MEMORANDUM

02 December 2022 (*revised 13 December 2022*)

**RE: Alki Elementary School – Departure Comment Responses
3039297-SD**

Above Right: Updated Roof Plan with highlighted Mechanical Penthouse, oriented north-south, dated December 2022

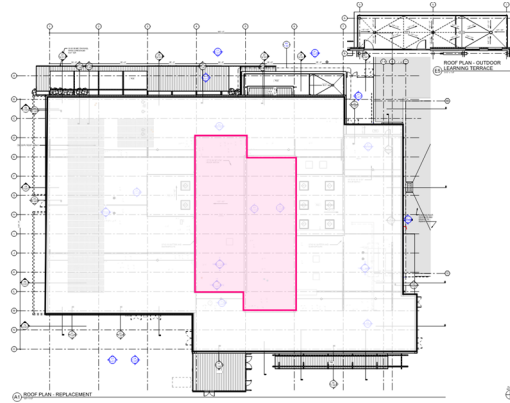
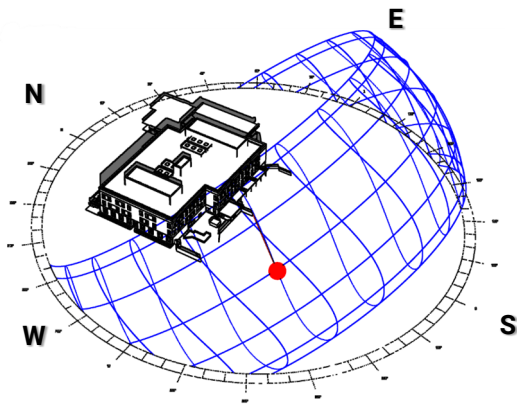
Several comments expressed concern over the requested Departure for building height stating the proposed design results in a building out-of-scale with the surrounding residential neighborhood and with potential adverse impacts to adjacent residences including views, shadowing, and noise from the rooftop mechanical units.

The proposed design calls for this Departure in order to meet the Seattle Public Schools' educational program specifications. A 500-seat school facility for the Alki Elementary School community accommodates potential growth, provides flexibility for changing program needs and demographics, and provides students with a safe and positive learning environment. SPS's planning approach balances the projected future regional and city growth with historical trends. The portions of the building that exceed the maximum height include the third floor of the main school building, the main school building roof parapet, and the mechanical penthouse, which is an enclosed room that protects equipment on the building roof. Enclosing the equipment increases longevity, reduces maintenance needs, allows for more energy-efficient equipment, and helps to reduce mechanical noise. The project team has progressed the design further since the Departure's presentation was completed a few months ago. As you can see from the updated roof plan on the following page, the long-side of the mechanical penthouse has been rotated away from the adjacent neighbors to the south.

The building's interior lighting will be tied to occupancy sensors as required by the Seattle Energy Code so that lights are not inadvertently left on to disturb neighboring residences after hours. The sun path diagram below illustrates that shadowing from the building will fall primarily on the playfield and will not impact these homes to the south.

Above: Site Plan Sketch illustrating reduced curb cut and curb cut flare widths

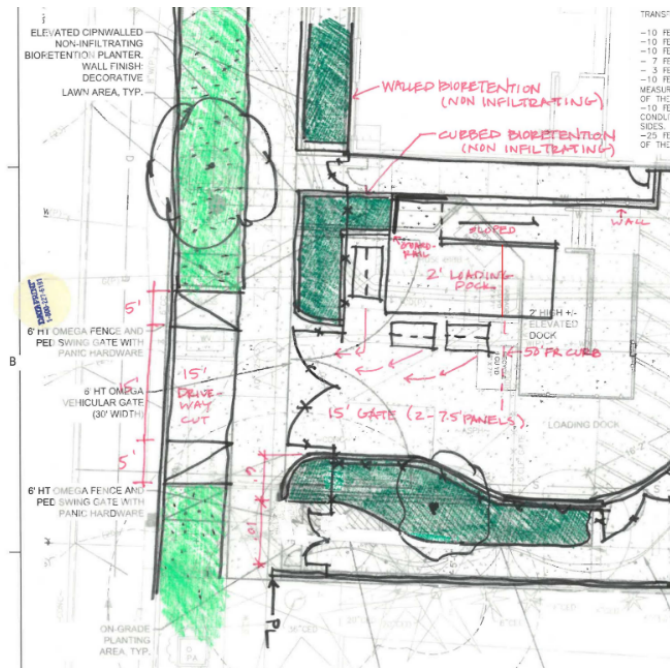
There were a few people expressing concern about the requested Departure for Curb Cut and Curb Cut Flare Width, stating that wider vehicular driveways are in conflict with pedestrian safety. The proposal maintains that this driveway does not pose a risk to pedestrians because it would only be accessed by professional drivers for either waste collection or deliveries during non-active hours. We are actively working on a new plan with SDOT that would reduce the curb cut and/or flare widths per the preliminary sketch below. While it is our hope to not exceed the allowable widths, conversations are ongoing with SDOT and we request the Departure in order to give them and the team flexibility in finding a solution.
